# Service Bulletin

**Subject:** Popping Noise from Front of Vehicle When Traveling Over Bumps

**Models:** 2013-2015 Cadillac ATS  
2014-2015 Cadillac CTS (VIN A)

*This PI has been revised to update the Parts Information. Please discard PI1510.*

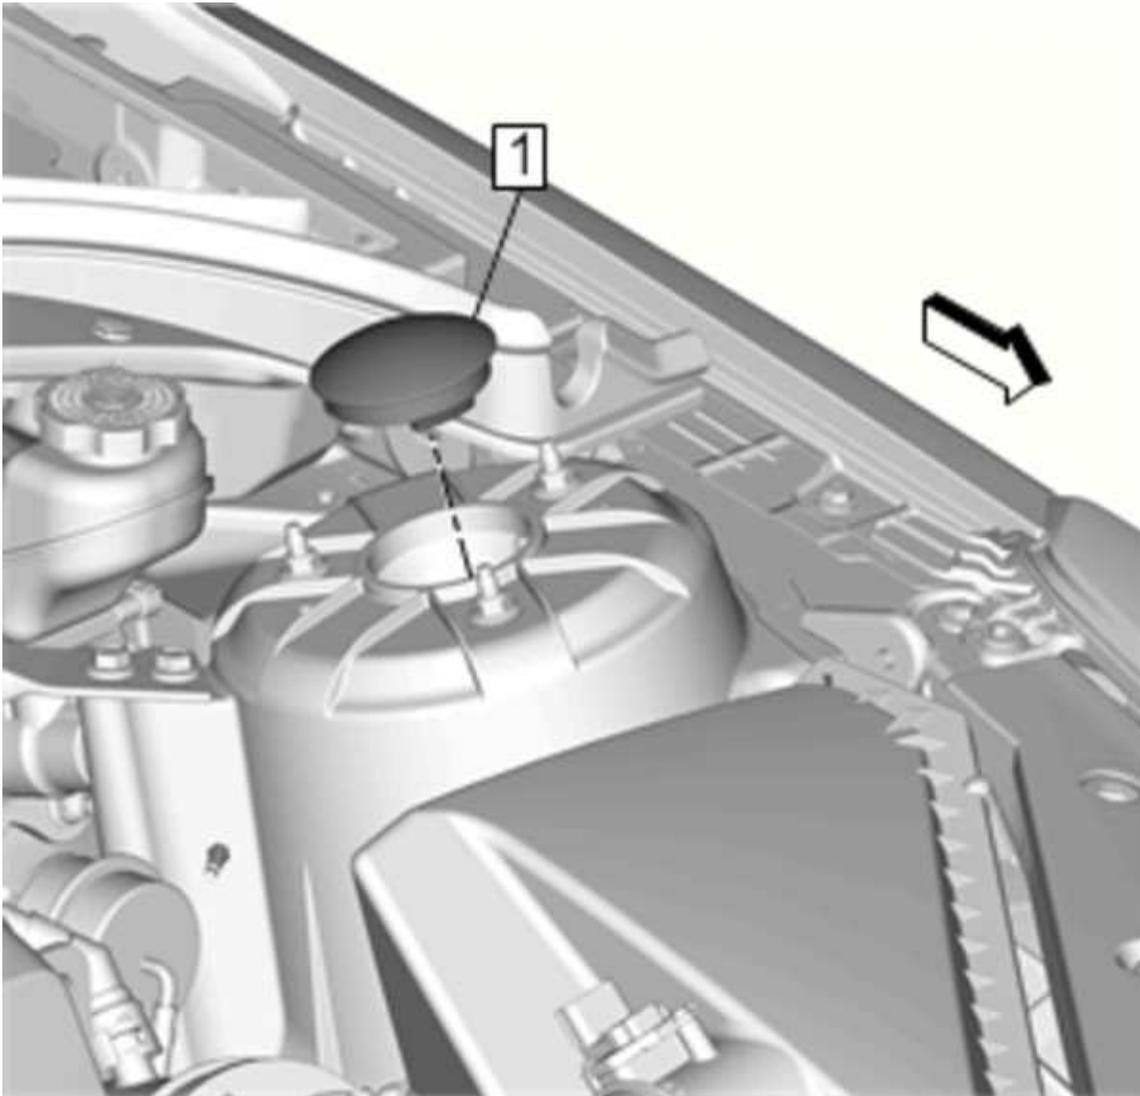
Some customers may comment on a popping noise when traveling over bumps.

This may be caused by the front strut mount being torn due to high underbody/underhood temps in addition to traveling over speed bumps.

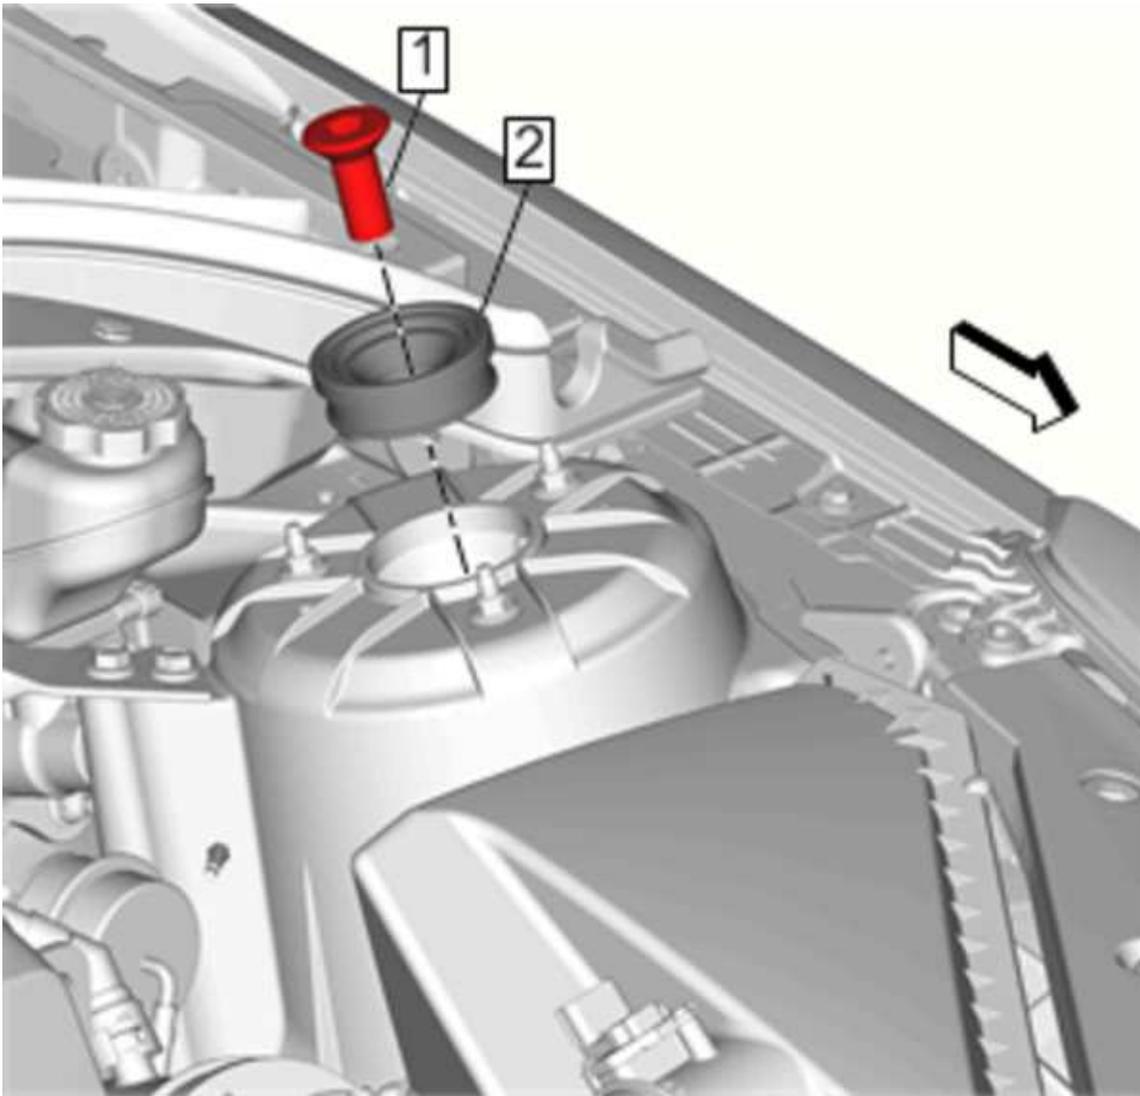
1. Remove and discard both the front suspension strut upper mounting caps (1).
2. Inspect both front strut top mounts from inside cavity for tears.  
If damage has occurred to the front strut mount, replace the both strut mounts. Refer to *Strut, Strut Component, or Spring Replacement* in SI.

**Note:** The following parts (1) and (2) will not be present in vehicles that exhibit this condition. The following parts are the permanent corrective action to prevent the front strut mount from tearing.

3. In addition to replacing the strut mounts, install both the front suspension strut mount upper rebound cups (2).
4. Install both the front suspension strut mount rebound stops (1) and tighten to 25 N•m (18 lb ft).

**Important:** Tighten with the vehicle resting on the ground and ensure rebound stop is fully seated against the strut rod nut.
